Report to Planning and Environment Committee

To: **Chair and Members**
Planning & Environment Committee
From: **George Kotsifas, P. Eng**
Managing Director, Development & Compliance Services &
Chief Building Official
Subject: **Housing Development Corporation, London**
345 Sylvan Street
SPA21-112

Public Participation Meeting on: January 31, 2022

<u>Site Plan</u>

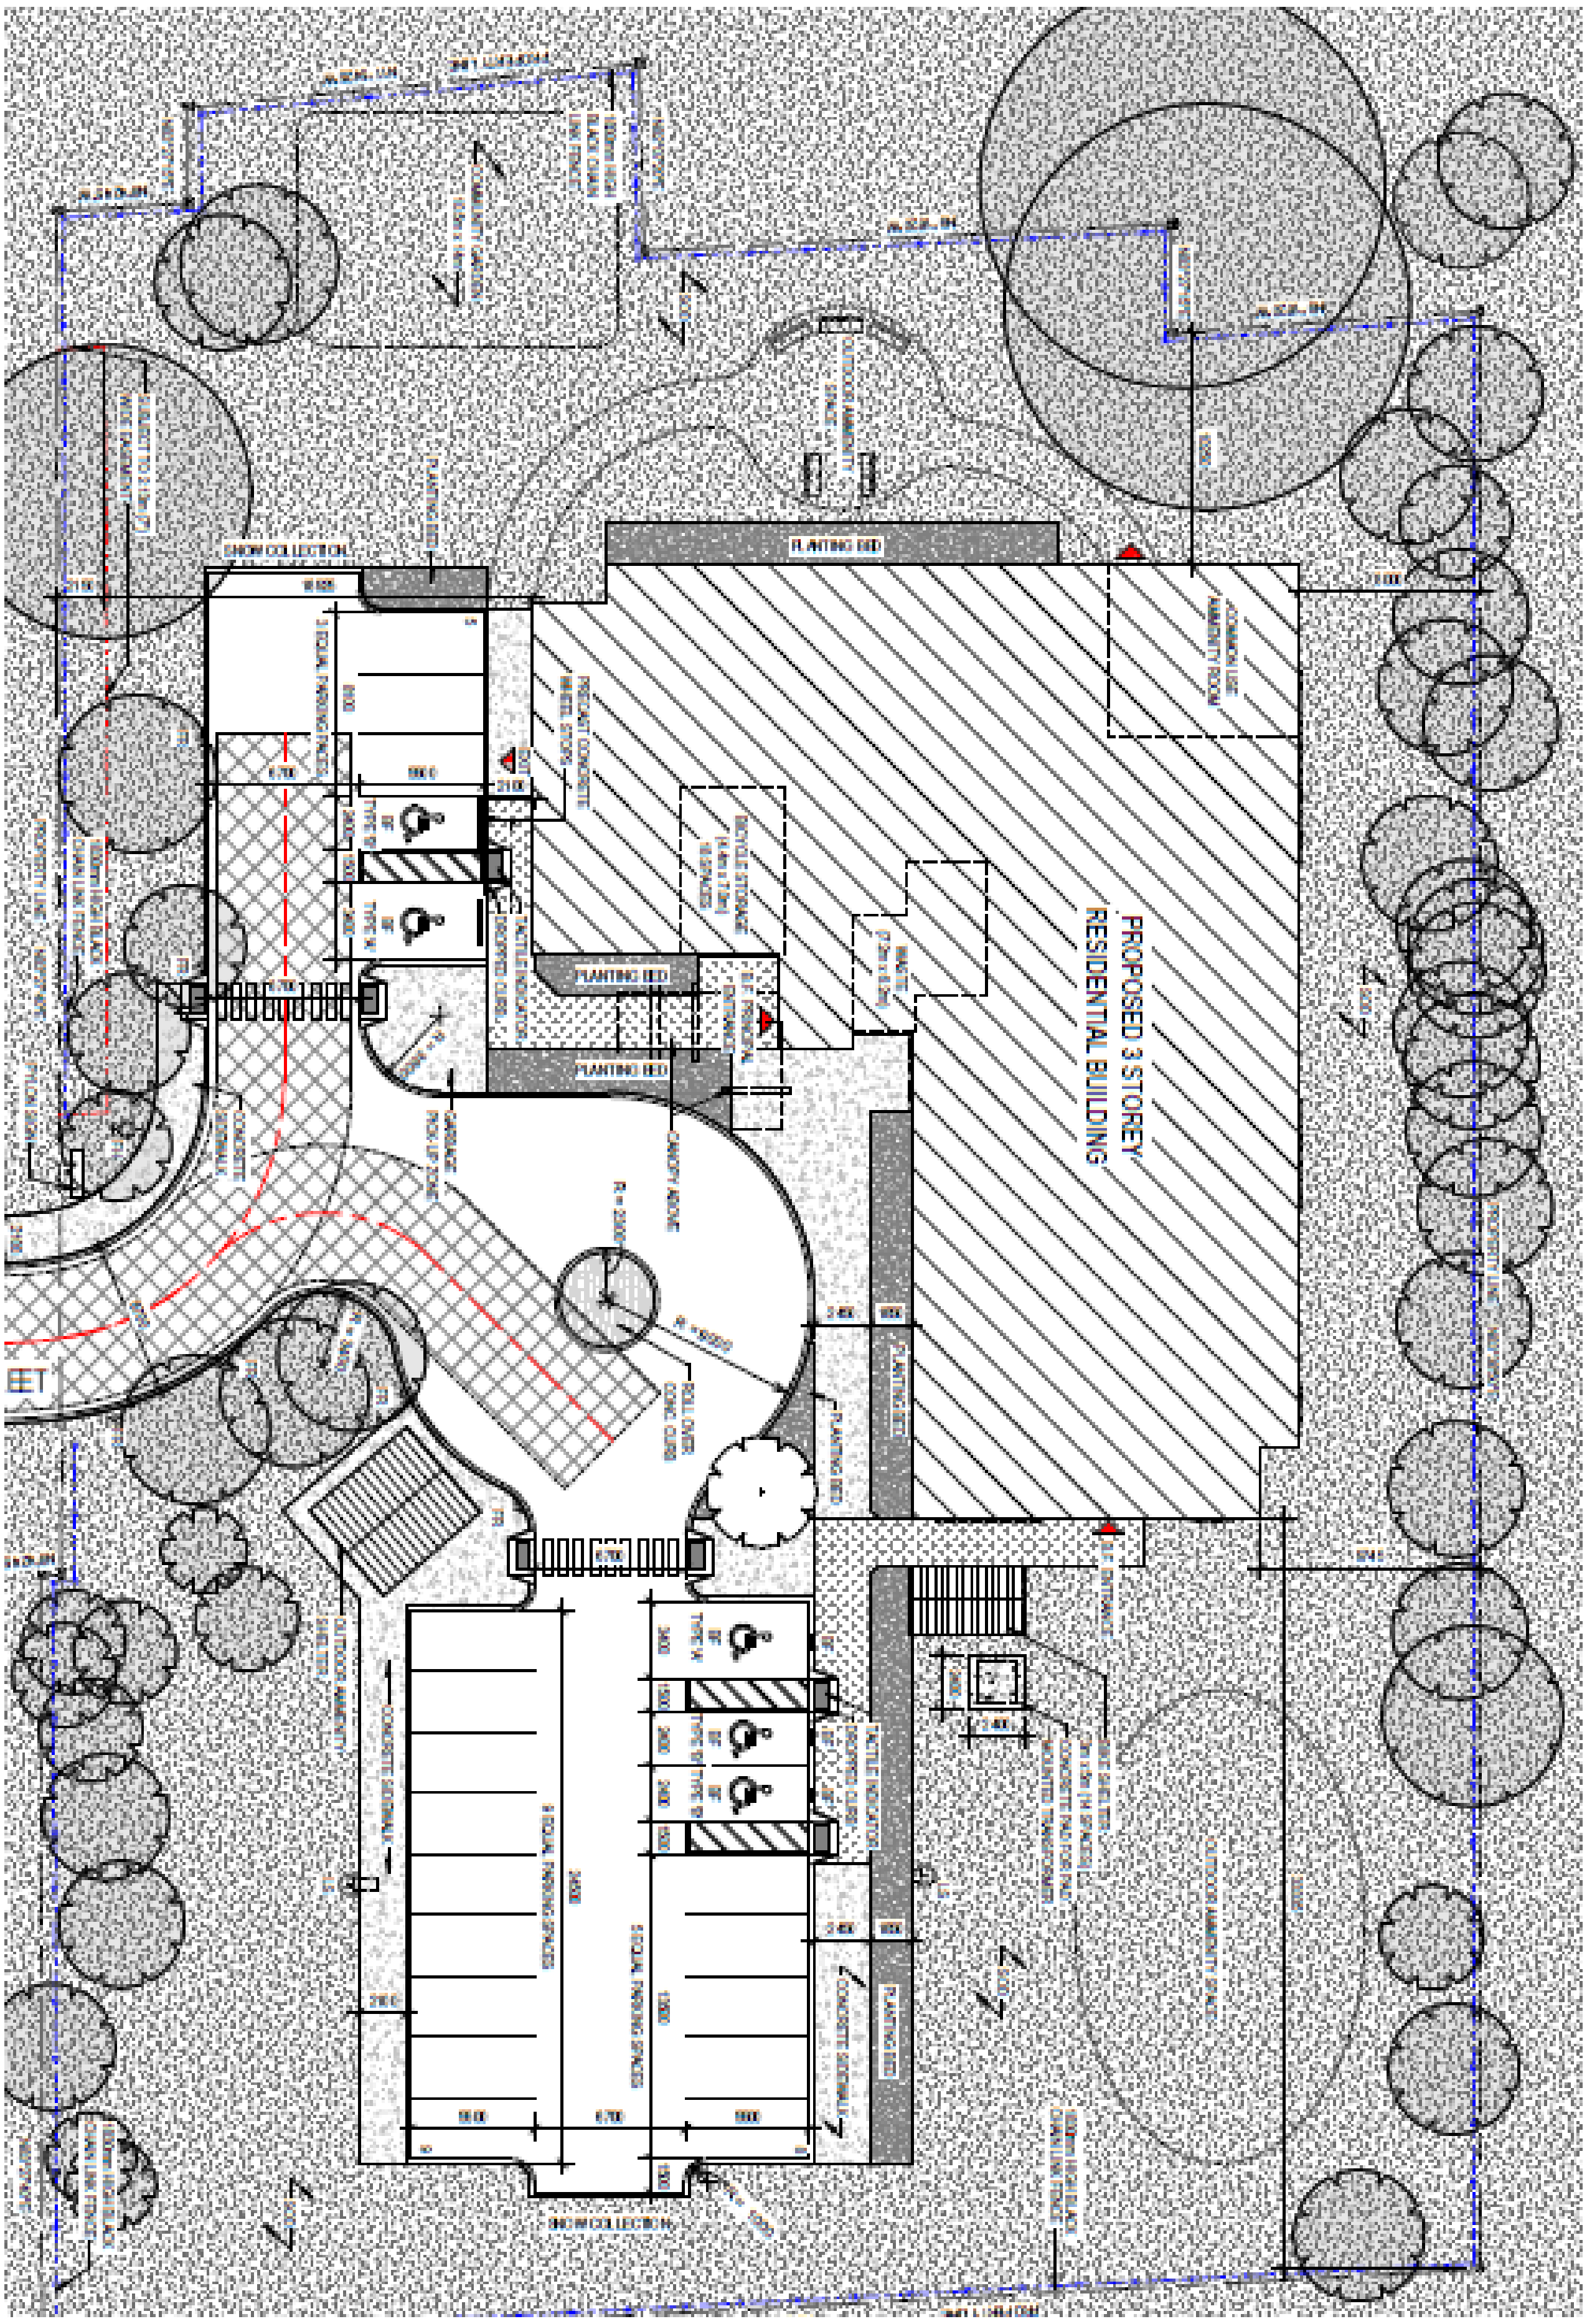
Site Engineering concerns at first submission are minor in nature with additional information rather than redesign being required for acceptance. The one exception relates to the alignment of the roundabout and its function for large vehicles including garbage trucks.

- Adjustments to lighting plans along the southern property boundary.
- Providing further detail on the external bike storage structure.
- Final review of tree preservation and servicing to ensure that there are no overlapping impacts.
- Tree planting in breaks/gaps of the existing vegetative screening along property lines.
- Screen parking lot and potential car light glare onto private residences.
- Reduce the amount of blank wall along the East elevation, as the elevation provided does not show any windows on bedroom side as it has shown on the perspectives.
- Shift the identified roundabout further east and align it with Sylvan Street.

Landscape Plan

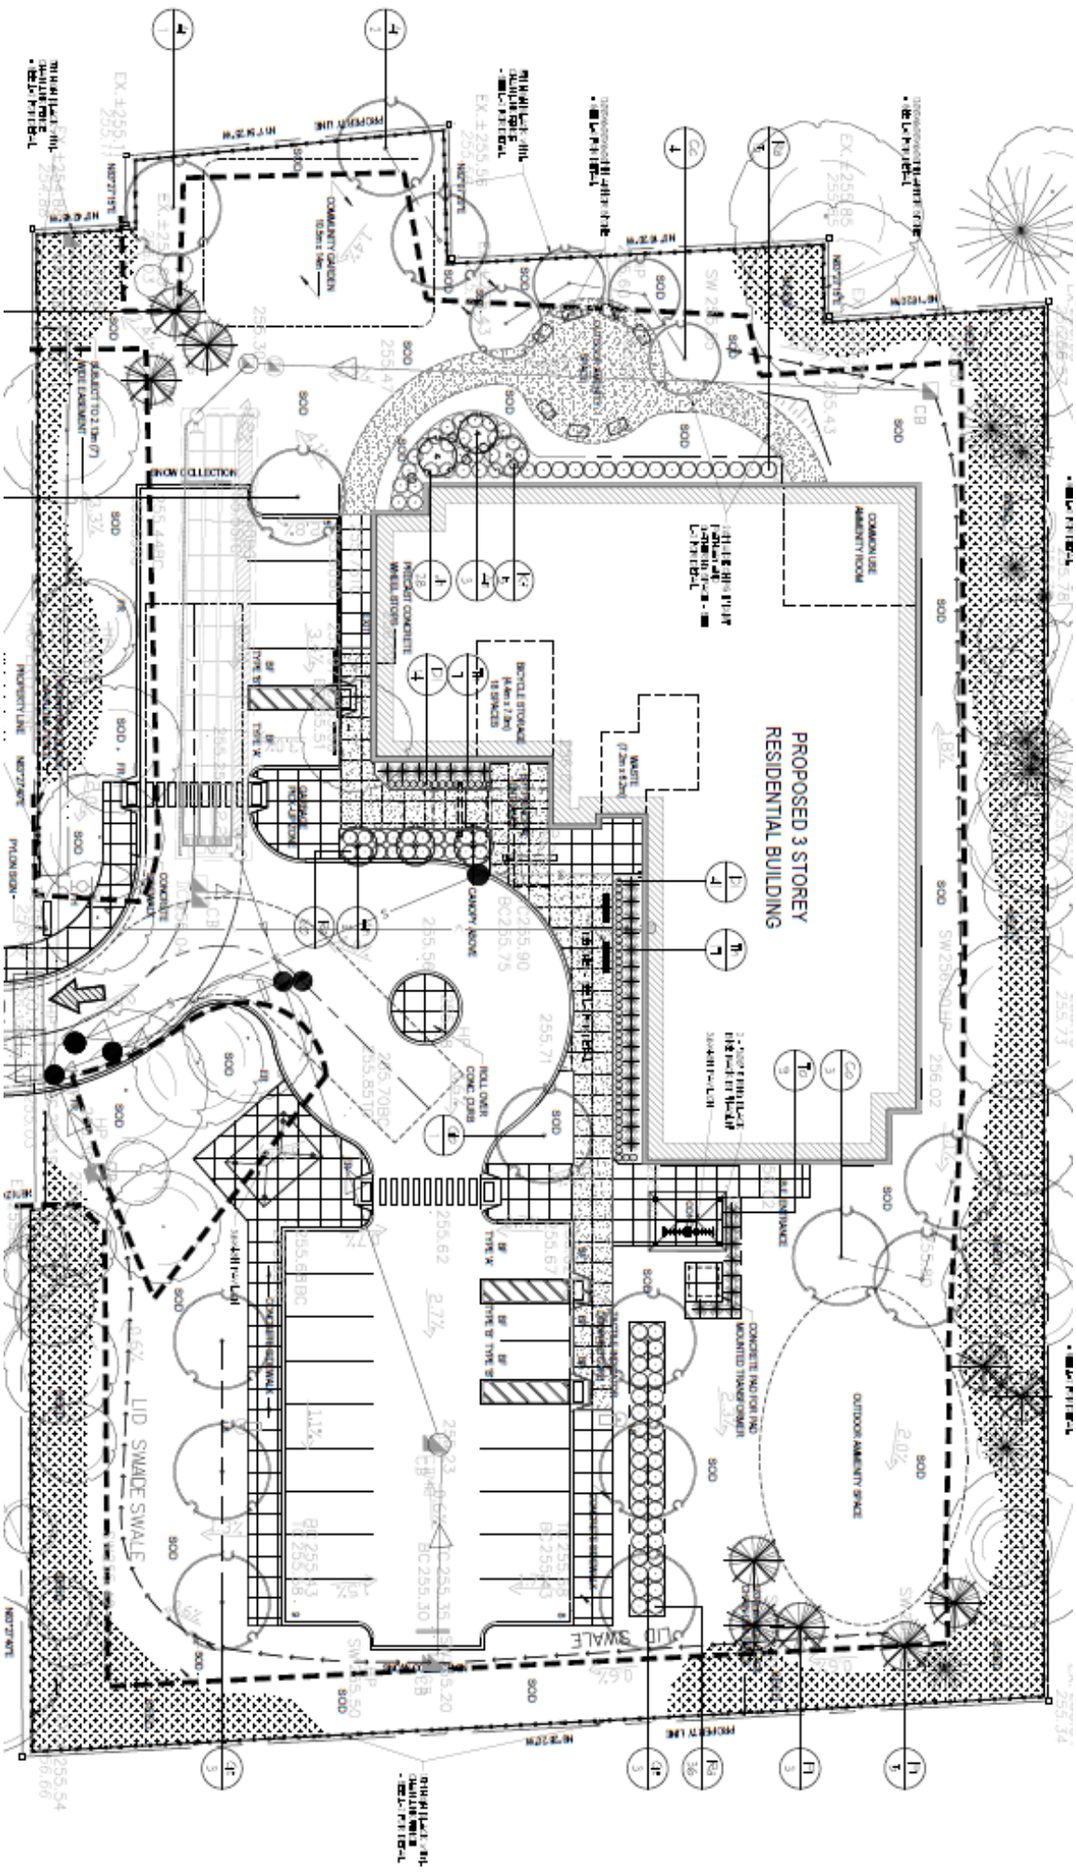
One reply was received in response to the notice sent our December 20, 2021. The respondent indicated a desire for a 1.8m fence along the entirety of the north property line. The respondent has been informed that the current proposal is for 1.8m chainlink fence along that property line.

We would be very happy to see a tall (min 6ft) solid fence be built along the entire property between 345 Sylvan and the rear of our property at 610 Percy, if the proposed building is erected at 345 Sylvan St. If this fence is tall enough to discourage climbers, solid, strong and has no areas of possible pass-through, we would be extremely happy. We here at 610 Percy value our privacy and security.
